UNITED STATES
DEPARTMENT OF THE INTERIOR
BUREAU OF LAND MANAGEMENT**HOBBS OGD**
OCD Hobbs
JAN 09 2018
RECEIVEDFORM APPROVED
OMB NO. 1004-0135
Expires: July 31, 2010**SUNDRY NOTICES AND REPORTS ON WELLS**
*Do not use this form for proposals to drill or to re-enter an abandoned well. Use form 3160-3 (APD) for such proposals.*Lease Serial No.
NMNM96050

☐ Oil Well ☒ Gas Well ☐ Other8. Well Name and No.
GAUCHO UNIT 12. Name of Operator
DEVON ENERGYContact: REBECCA DEAL
E-Mail: Rebecca.Deal@dvn.com9. API Well No.
30-025-334403a. Address
333 WEST SHERIDAN
OKLAHOMA CITY, OK 731023b. Phone No. (include area code)
Ph: 405-228-842910. Field and Pool, or Exploratory
WEST OJO CHISO (MORROW)

Devon Energy Production Co., L.P. respectfully requests to plug back the Gauchito Unit #1 due to offset concerns in order to increase production. Proposed operations as follows:

Well Name: GAUCHO UNIT #1		Field: WILDCAT	
Location: 1650' FNL & 1650' FEL; SEC 29-T22S-R34E		County: LEA	State: NM
Elevation: 3429' GL		Spud Date: 5/31/96	Compl Date: 10/23/96
API#: 30-025-33440	Prepared by: Ronnie Slack	Date: 3/29/10	Rev:

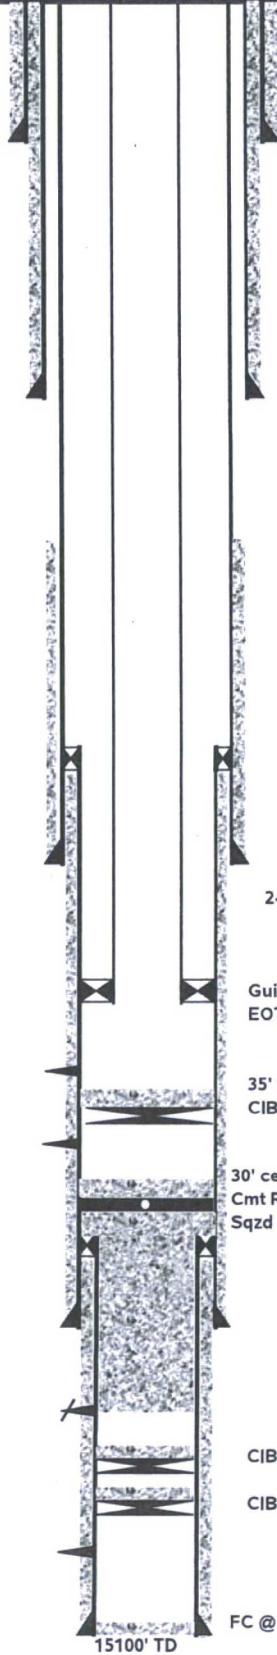
- Hold Prejob Safety Meeting
- MIRU Workover Unit
- ND WH, NU BOPE and Test
- Unset packer and TOH with tubing and packer
- MIRU WL unit
- Make gauge ring/junk basket run to 13,267? (50' above proposed interval in which we plan to plug back)
- RIH with CIBP and set bridge plug at 13,267?
- Dump bail 35' cement on top of bridge plug, WOC

- TIH with packer and production tubing ? set packer and test plug to 500 psi with chart test and BLM witness
- Unset packer, move uphole to reset packer at 12,893?
- Return well to production

35' Cement from 13,232'-13267'
CIBP set at 13,267'

In lieu of a cement plug across perforations in a cased hole (not for any other plugs), a bridge plug set within 50 feet to 100 feet above the perforations shall be capped with 25 sacks of cement.

Before pumping cement on top of CIBP, tag will be required to verify depth. Based on depth, a tag of the cement may be deemed necessary.

Unless otherwise specified in the approved procedure, the cement plug shall consist of either **Neat Class "C"**, for up to 7,500 feet of depth or **Neat Class "H"**, for deeper than 7,500 feet plugs.
